Reference: Beaver Valley Power Station, Unit No. 1  
Docket No. 50-334, License No. DPR-66  
Class 3 Pipe Support Relief Request

Beaver Valley Power Station, Unit No. 1  
Docket No. 50-334, License No. DPR-66  
Class 3 Pipe Support Relief Request  
Page 2

### Class 3 Piping Support Relief Request

FIGURE 13

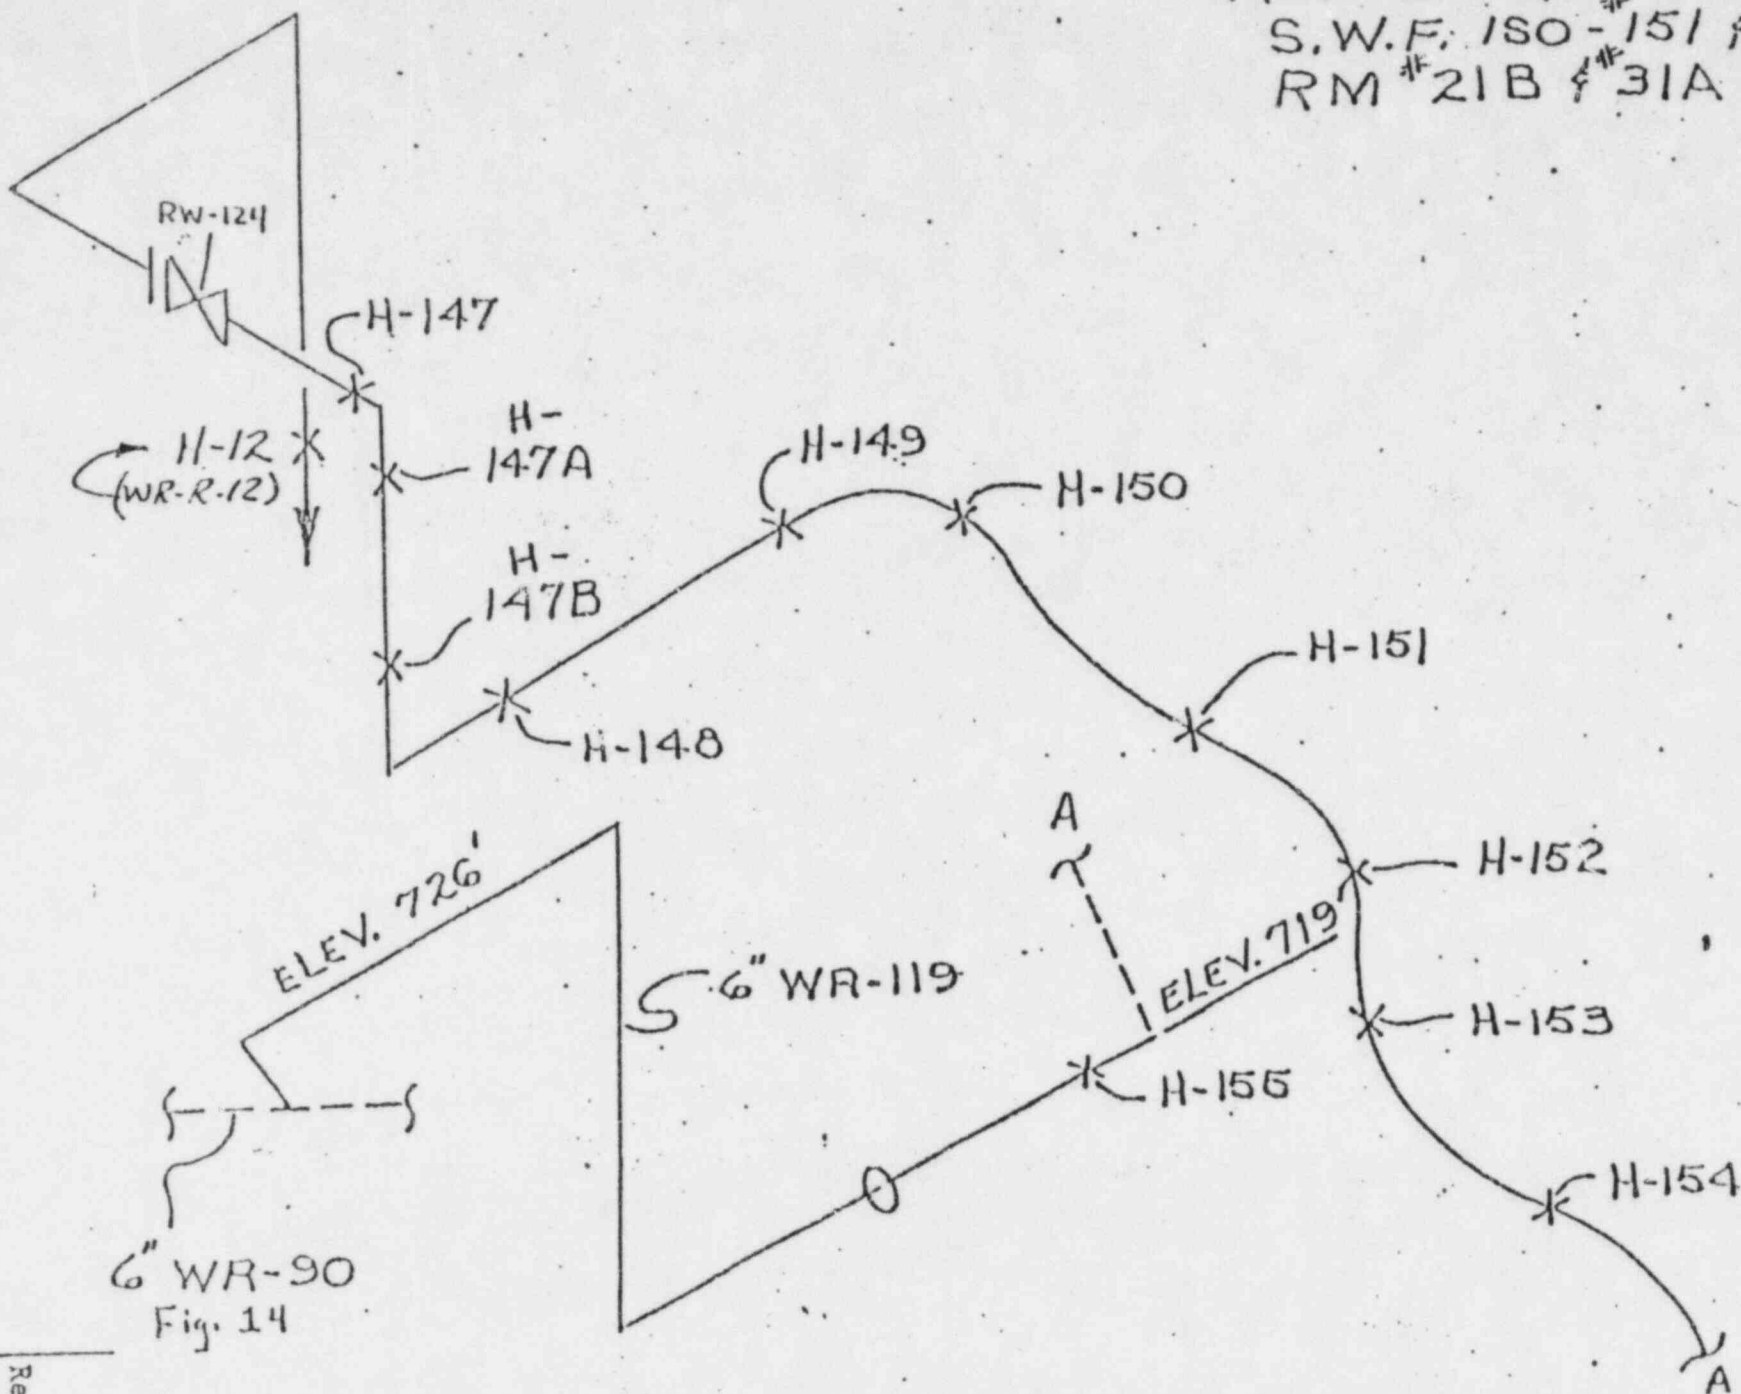
The following supports shown on Figure 13 are located at the bottom of the pipe trench outside the Fuel Handling Building and are inaccessible for visual examination due to the large amount of small bore piping which precludes access into the pipe trench and severely limits the visibility of these supports:

WR-R-153 (H-153)

WR-R-154 (H-154)

WR-R-155 (H-155)

The following examination is being suggested for all five (5) supports listed above. Perform a best effort visual examination utilizing the appropriate visual aids to improve the inspectability to the greatest extent possible. This best effort examination shall be done to detect any loss of support capability, and evidence of inadequate restraint.
